RE: TEDS Exception from Minimum Curve Radius at 25 ½ Road & Cosby Avenue

DESIGN EXCEPTION #DE24-02

RE: Exception from Minimum Curve Radius at 25 1/2 Road & Cosby Avenue

RE: Traffic Engineering Design Standards (TEDS) Exception
Section 5.1.4.2, Curve Radius
25 ½ Road Extension to Crosby Avenue

FIGURE 1

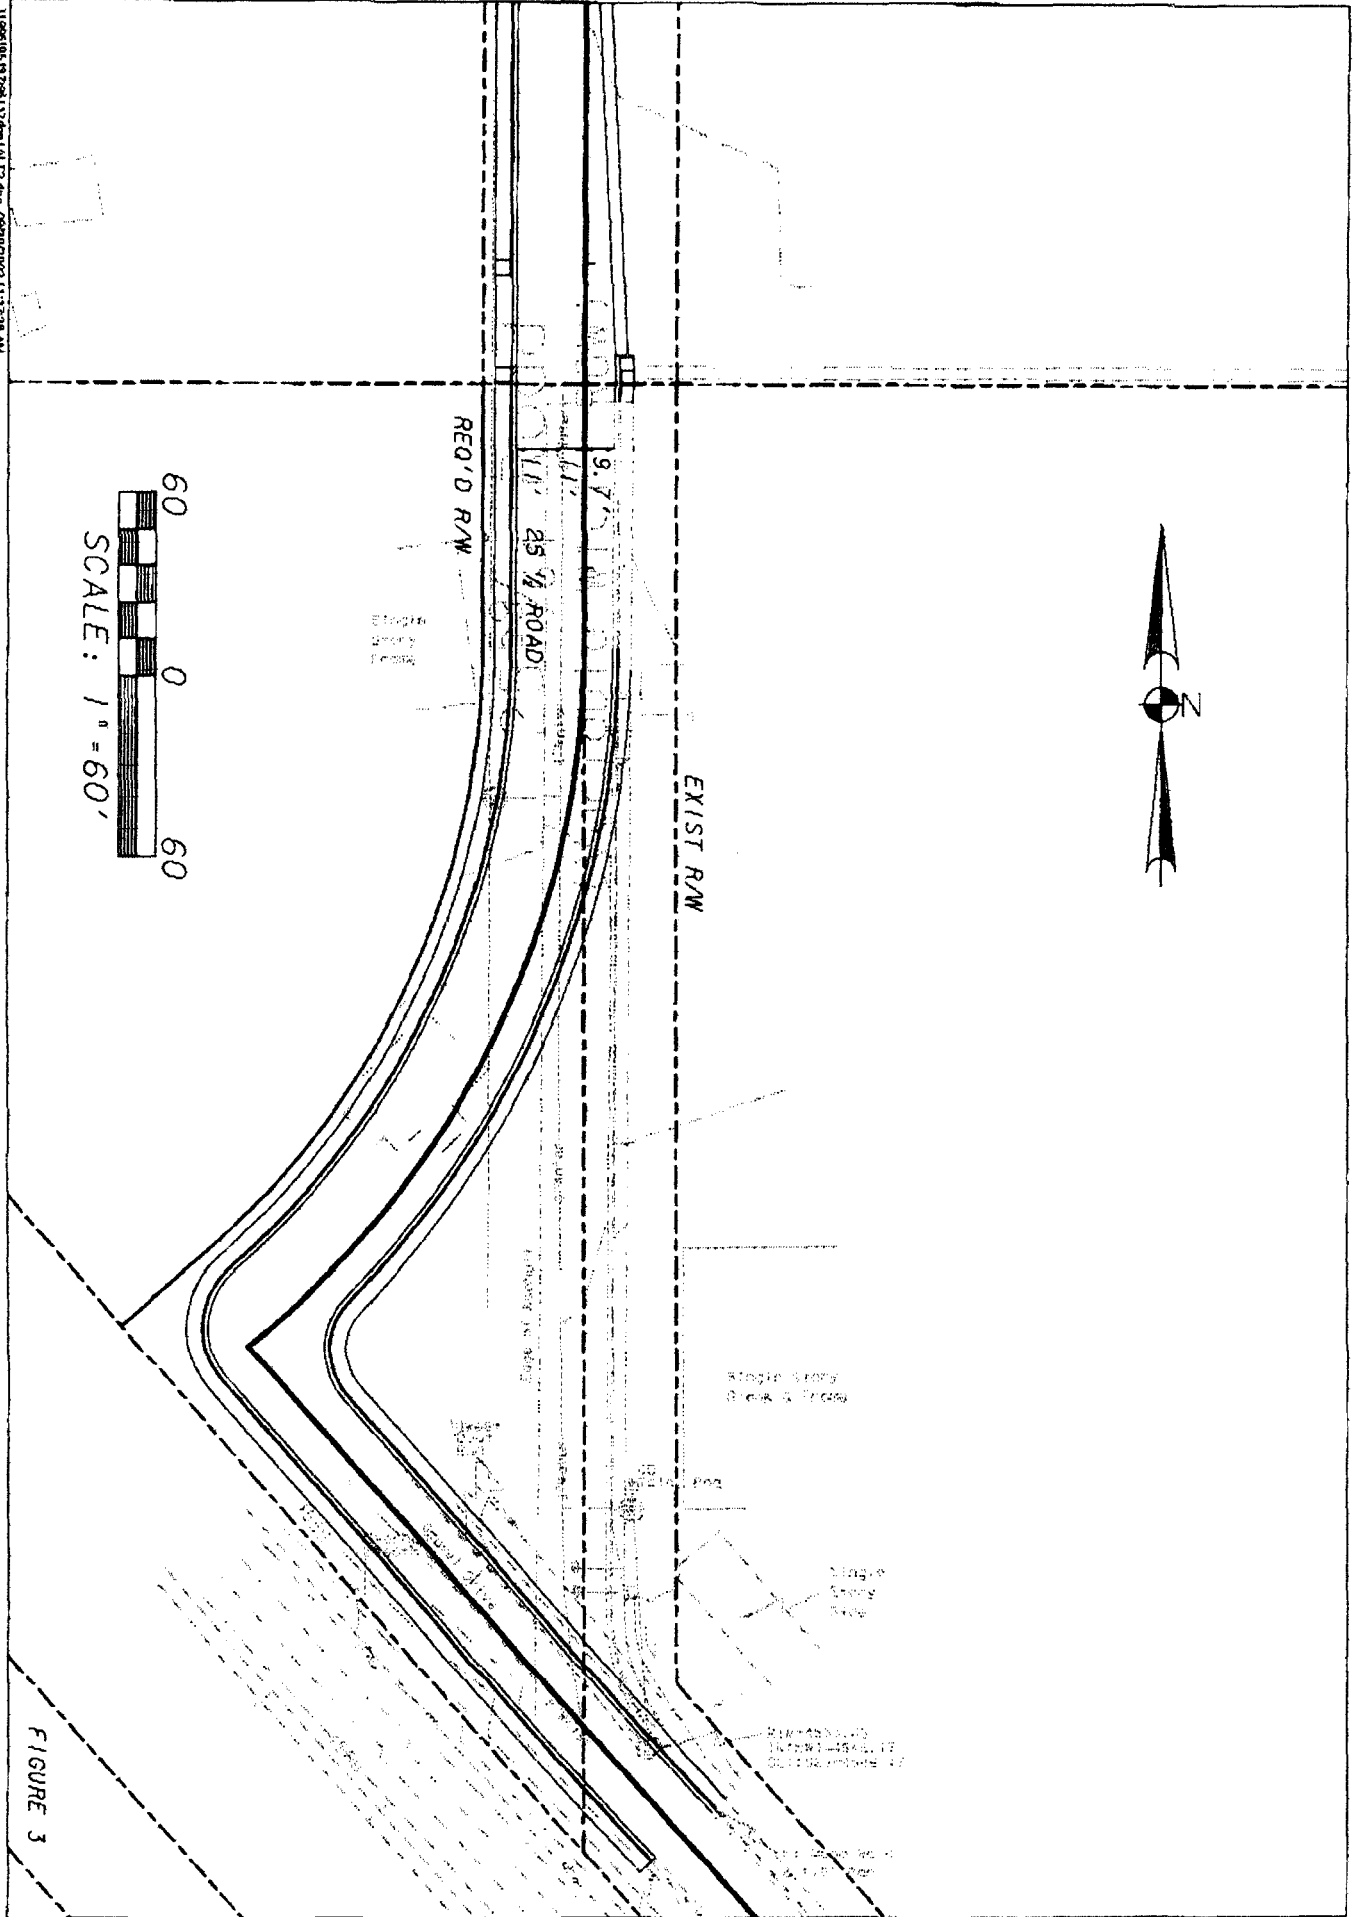
Their current plan proposes to extend the radius across the street to the west flowline and transition the street width to match the fully constructed portion of Cosby Avenue immediately southeast of the match point. This would create a centerline radius of only 95 feet.

Due to the design constraints of providing a 300' radius curve for the transition from 25 ½ Road to Crosby Avenue, Wolverton and Associates proposes a radius of 95' for this intersection. The design constraints which cause this need for a design exception include: Excessive right of way impacts, Impacts to a building located on the property from which right of way would need to be attained, Additional construction costs due to the reconstruction of existing curb, gutter and sidewalk, and the relocation of utilities (sanitary sewer, telephone). See figure 1 for proposed design.

Because there are no other streets intersecting at or near the point that these two streets meet, proper signing should eliminate any safety concerns with the proposed configuration.

The applicant proposed two other options that would comply with TEDS. The first would require removal of the existing building and acquiring additional right-of-way along the east side. This option would create a long tail of unusable property between the street and the railroad and add no particular benefit.

The second option would curve 25 ½ Road to the southwest until it was perpendicular to the extension of Cosby Avenue. This alignment would require considerably more right-of-way from the property to the west and a similar unusable strip along the east side. It would also require traffic to come to almost a complete stop to make the turn at the new intersection.

I recommend approval of the requested Design Exceptions to Section 5.1.4.2 to allow a reduced centerline radius at the connection of 25 1/2 Road and Cosby Avenue.
